GEORGE M.
JANES &
ASSOCIATES

RE: SEQRA
Review of PDEIS for
Overton Subdivision
Village of Tuxedo Park
Orange County, New York

Figure 1: Reproduction of a portion of PDEIS Figure 3.5.5, showing the viewshed map

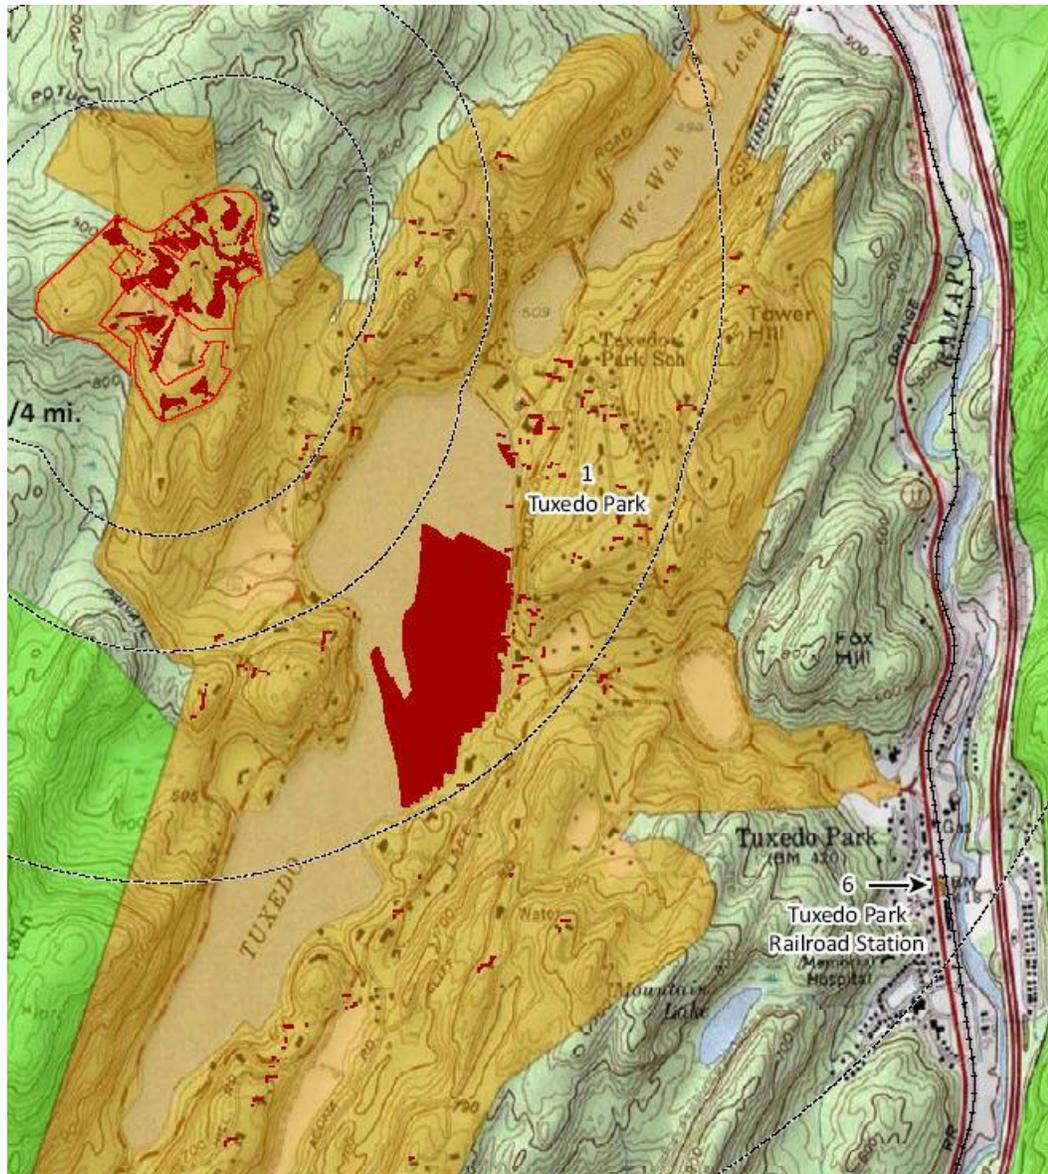
I have many serious concerns with both the text and the viewshed mapping used as evidence to support that text. First, the viewshed analysis presented does not indicate that at 70 feet tall, the top five feet of the homes located on Lots 6 and 9 may be visible from limited areas of Tuxedo Lake. There are ways to support this assertion, but the viewshed map shown in the PDEIS is not one of them. Instead, the viewshed map in the PDEIS shows where the project, as a whole, may have visibility considering the building heights and assumptions about existing trees. The following is a small portion of the viewshed shown in the PDEIS. The red areas show from where the project may have visibility.

The viewshed shows that the project has limited visibility to most of Tuxedo Park. But there is a large portion of potential visibility on Tuxedo Lake. Regarding this visibility, the text says that, “It is likely that, *given existing vegetation along the shoreline*, views would be filtered, of short duration, and in the middle ground.” [Emphasis added.]

While there are trees between some portions of East Lake Road and the Lake, there is a long stretch, north of Tuxedo Road, where there is no vegetation along the shoreline side of East Lake Road that would filter views to the project.

Any assertions or claims made need to be supported by evidence. The PDEIS viewshed mapping is clearly inaccurate in its assessment of the visibility from the northern portion of East Lake Road. Further, PDEIS provides no evidence to support claims regarding the impact and effectiveness of the mitigation measures regarding lots 6 and 9. The applicant needs to correct this analysis and add information to support assertions made regarding the impacts of individual lots.

Figure 2: NOAA data for a portion of Tuxedo Park

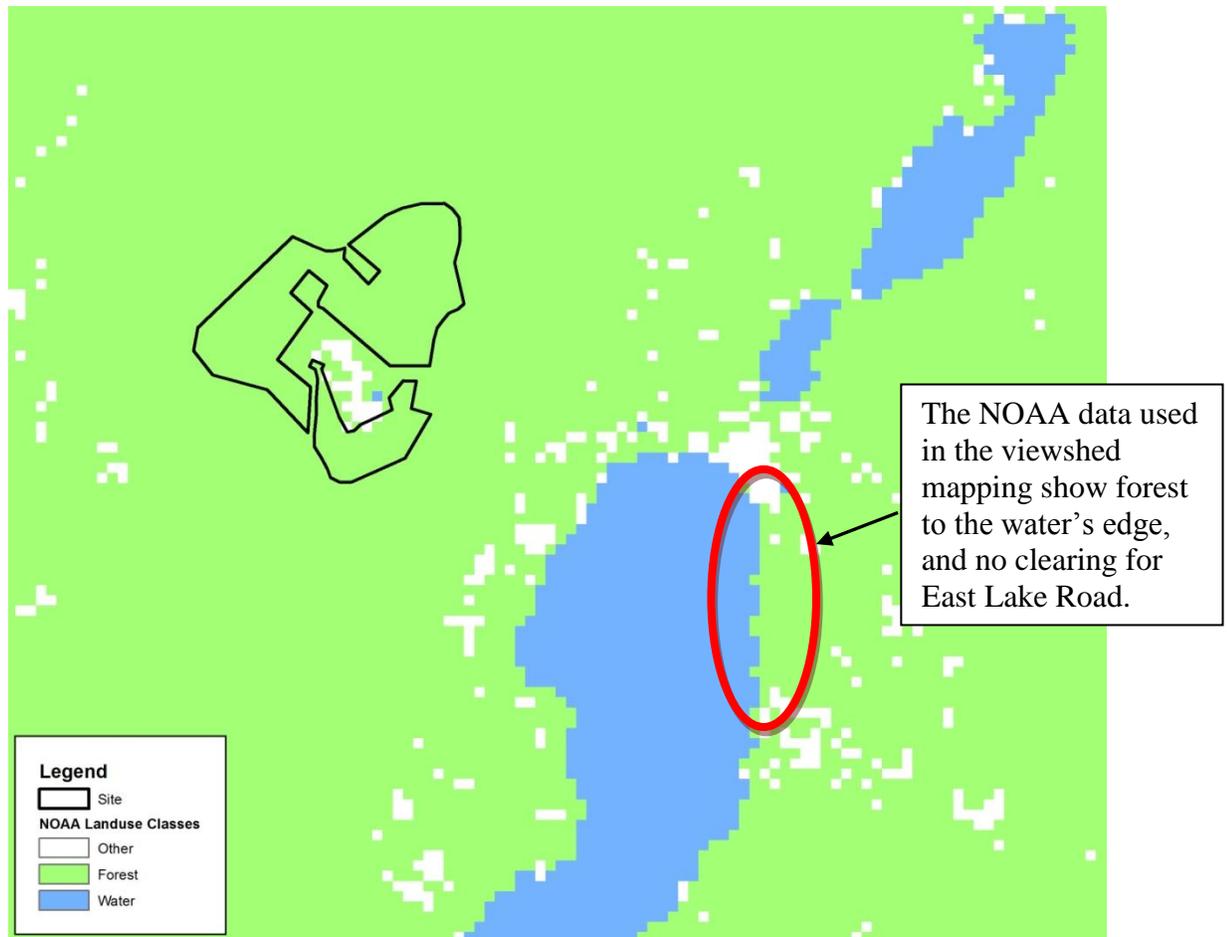
The method used for the viewshed map defines forested areas as obstructions to visibility, and since the NOAA data classifies the eastern shoreline of the Tuxedo Lake north of Tuxedo Road as forested—where in reality there is a road and a clear view to the project site for much of this shore—the viewshed map and the text inaccurately indicate limited visibility from this area.

Figure 3: Independently derived viewshed map using NOAA data, with all buildings at 70 feet

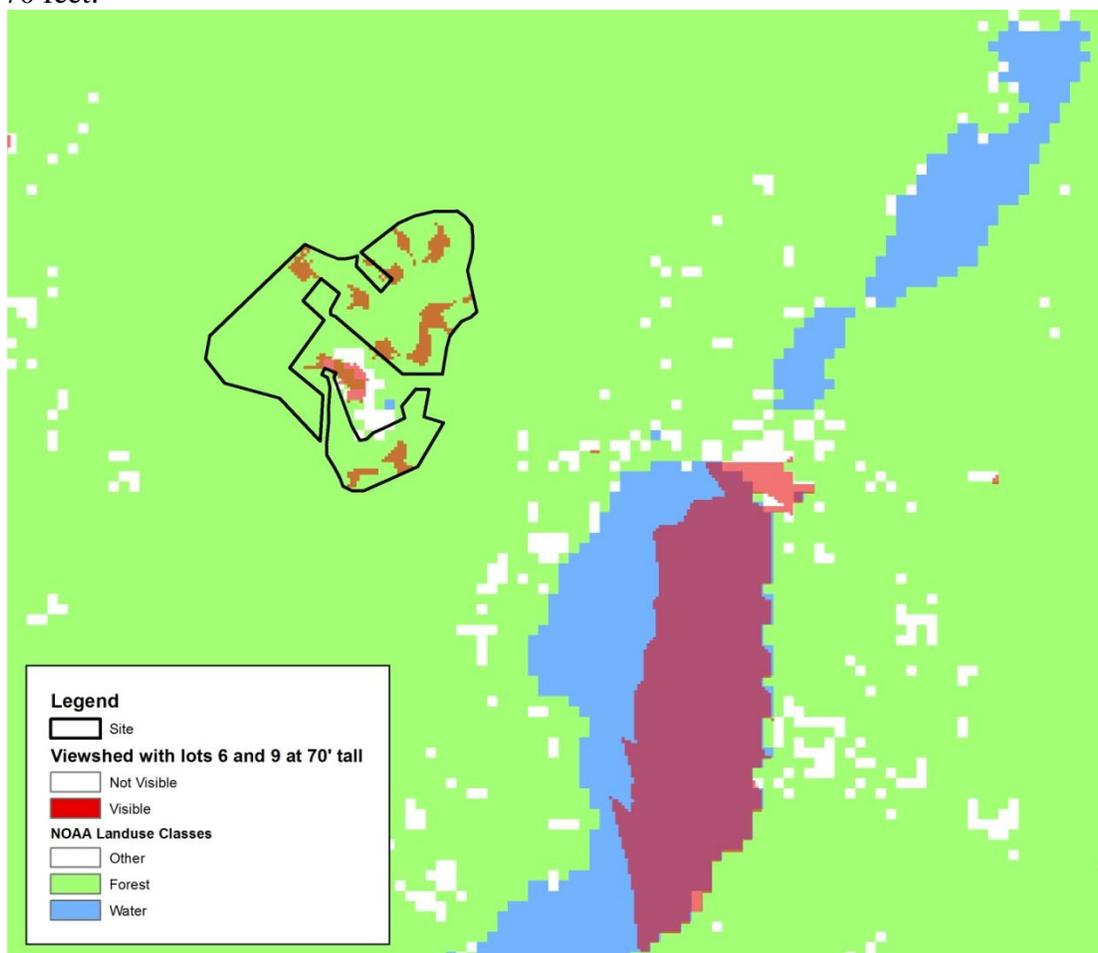
The following series of viewshed maps for the proposed project use the NOAA vegetation data⁵ that were reportedly used as inputs into the viewshed mapping found in the PDEIS. These were made by my office⁶ using the same assumptions regarding tree height used by the applicant. They have been done quickly to address this specific issue and have not been formatted to show scale, north arrows, etc. These maps highlight my area of concern: the northern portion of East Lake Road.⁷

This map shows areas with visibility to the project site in red with all buildings at 70 feet:

Figure 4: Independently derived viewshed map using NOAA data. Lots 6 & 9 at 65 feet, all other lots at 70 feet

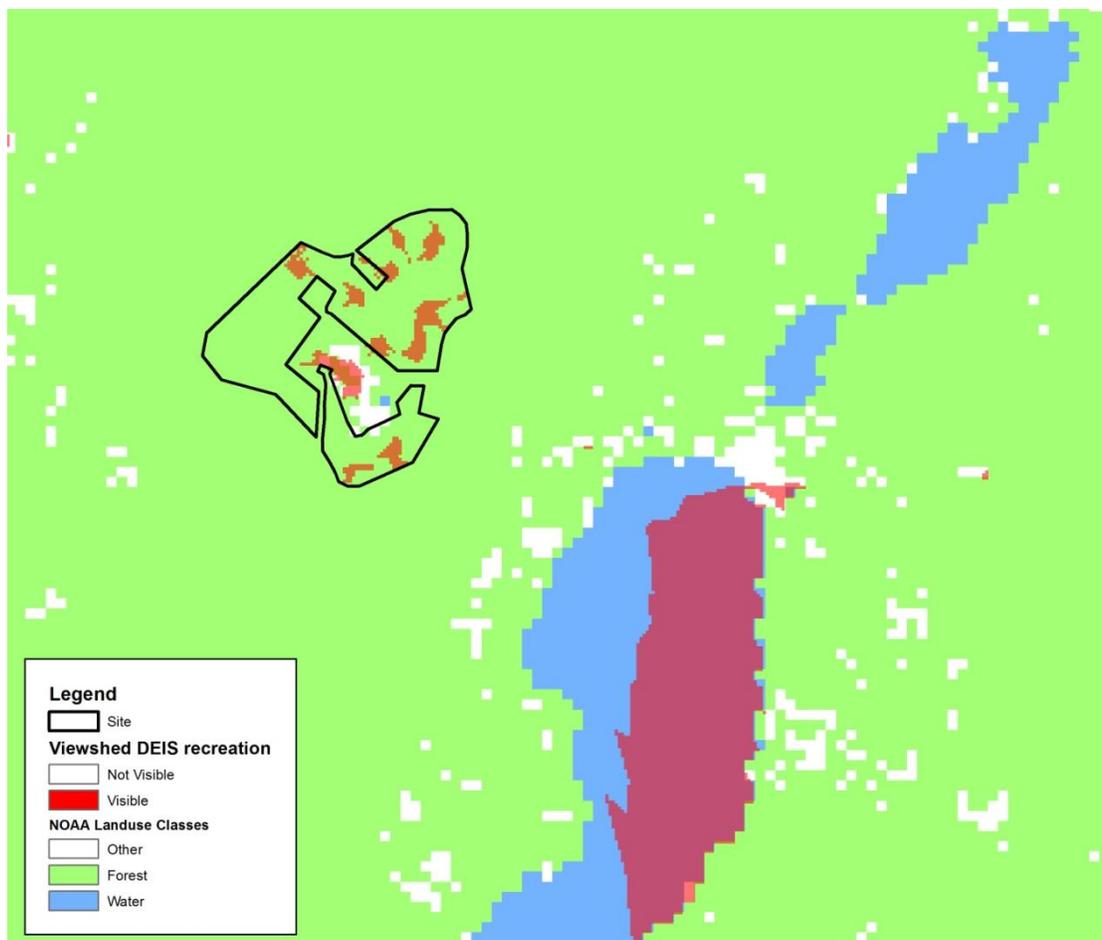
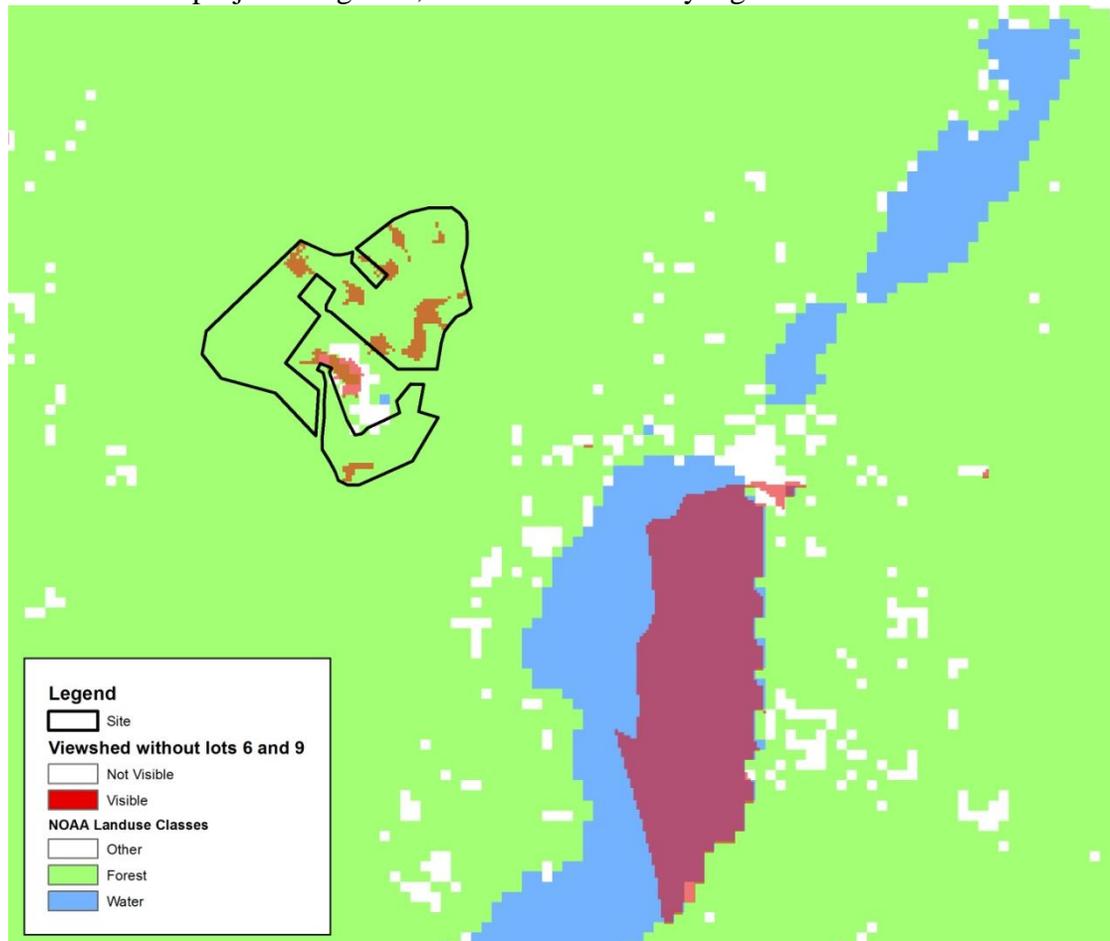
This map shows the project visibility when the height of lots 6 and 9 are reduced to 65 feet, which is one of the mitigation measures designed to reduce the project's visibility.

The following shows the visibility of the project without lots 6 and 9, removing them from the project altogether, so that there are only eight houses.

This series of viewsheds suggest that the mitigation measure of reducing the height of lots 6 and 9 have a trivial impact on overall project visibility and that even without lots 6 and 9 at least some of the remaining eight houses will have clear visibility to the northern portion of East Lake Road.

Figure 6: Reproduction of a portion of Figure 3.5.3

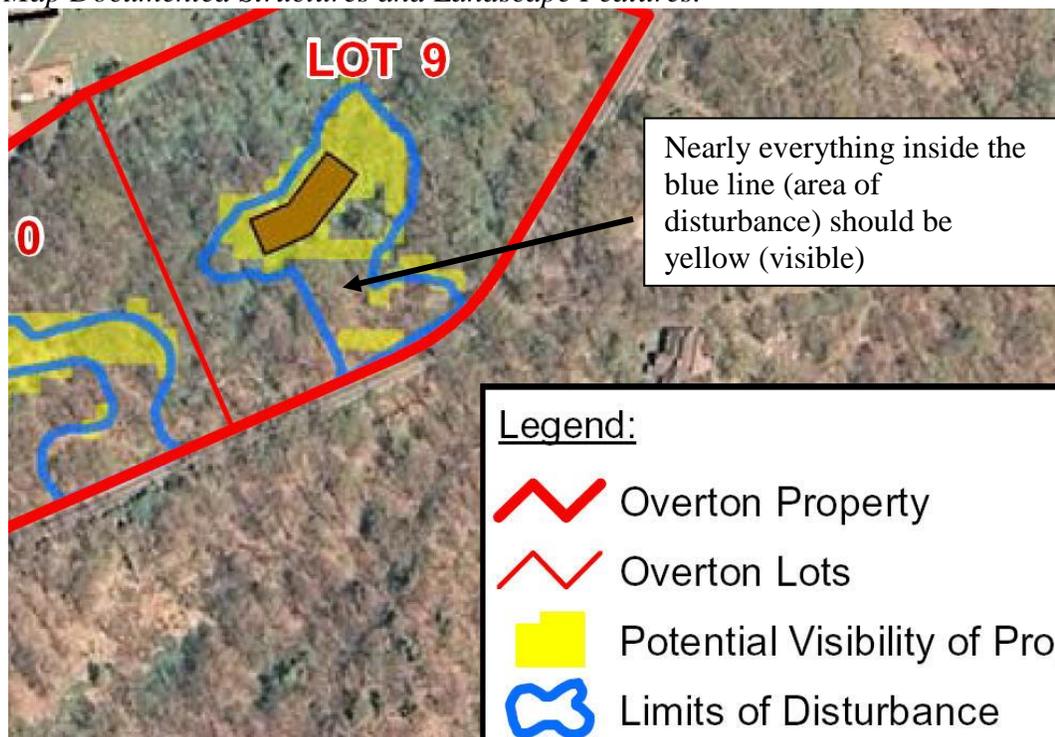
The brown polygon is the footprint for a proposed building. The area outlined in blue is the area of disturbance. The yellow shows areas where a building is potentially visible. One would expect that nearly the entire area outlined in blue, where trees have been removed, would have visibility to a 65 foot tall building on the same lot. Yet, this map shows that much this area would not have visibility to this building, which defies logic.

This odd result may be the result of a glitch in the method used to determine visibility, or the applicant may be assuming that “Any trees, shrubs, and/or hedges to be removed during construction must be replanted in as good a condition as they

were in before they were removed and any damaged trees, shrubs, and/or hedges must be replaced (in-kind) at the contractor's expense." Yet, the applicant is assuming that these trees *average* 70 feet tall. If a 70 or 80 foot tall tree is removed during construction, this statement appears to be committing to the replacement of the same tree, which is exceptional for such large trees (the note on the SP 4 offers *ornamental* trees will be replaced). Generally, visibility analyses are done removing all trees from within the area of disturbance, assuming that general landscaping elements will provide little screening at time of planting, unless they are specifically designed as a screen. Even if individual trees from previously forested areas are salvaged and incorporated into the landscape, the area of disturbance cannot be considered forested for the purposes of visibility analysis because these trees typically offer little screening due to their lack of branches. In the absence of a landscape plan, the analysis should not assume there is any screening offered from within disturbed areas and this and any other map or analysis that assumes otherwise should be redone.⁹

Figure 7: NOAA forest data on an aerial photograph of part of Tuxedo Park

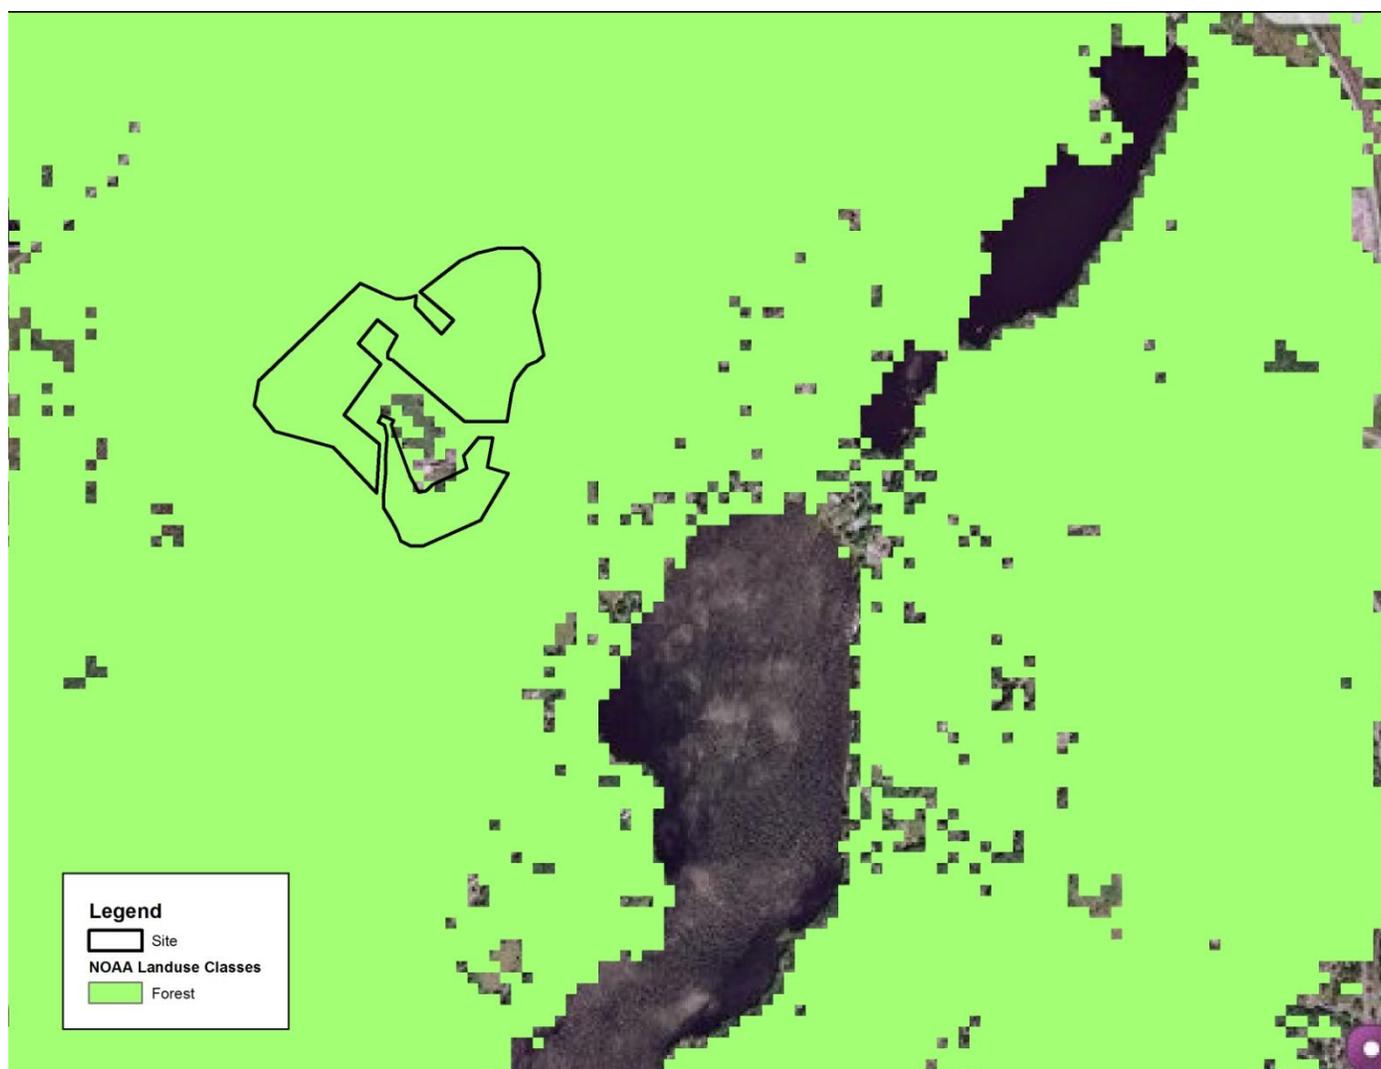
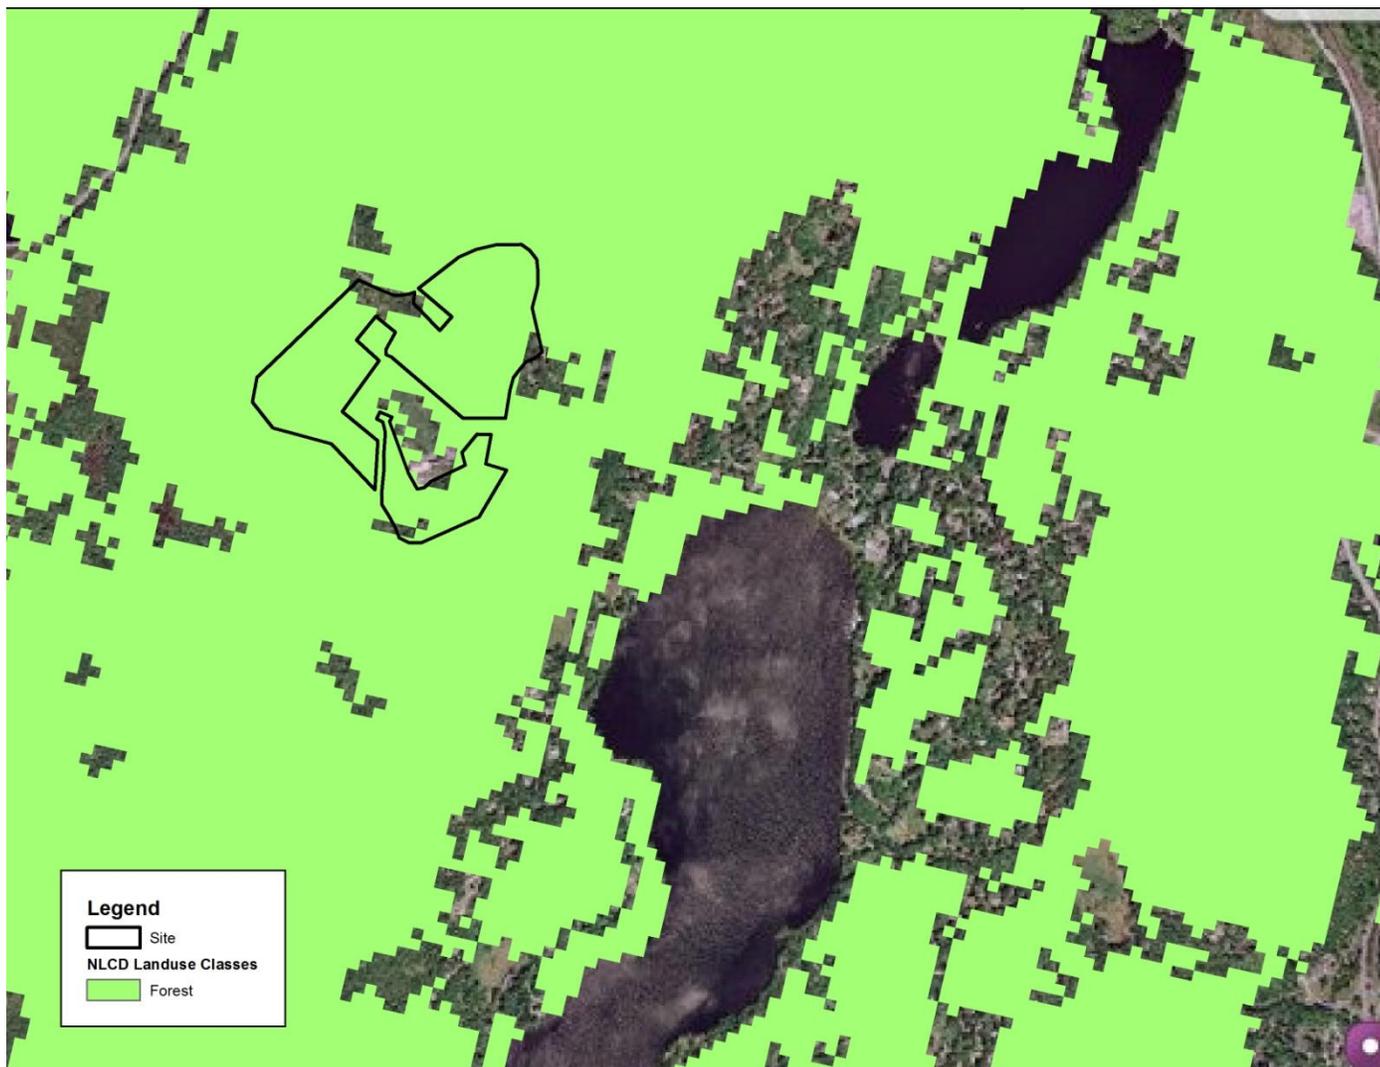
This map shows the NOAA forest data, which shows nearly the entire non-lake portion of the Village covered in forest:

The NLCD data shows much less of the Village as forested. It acknowledges that large areas on the eastern shore of Tuxedo Lake are not forested and also eliminates much of the forests on built lots to the north and east of Tuxedo Lake. It instead classifies much of this land as developed. The data sets clearly use different criteria when classifying land.

Typically under SEQR when given two otherwise equal sources of data, the one that discloses a larger impact should be used. The information in a DEIS should always err the side of disclosing more, rather than risking understating a project's impacts. So unless there is a compelling reason to use the NOAA data, the NLCD data would be preferable for viewsheds in Tuxedo Park because they show fewer forested areas and will result in a viewshed analysis that discloses more visibility.
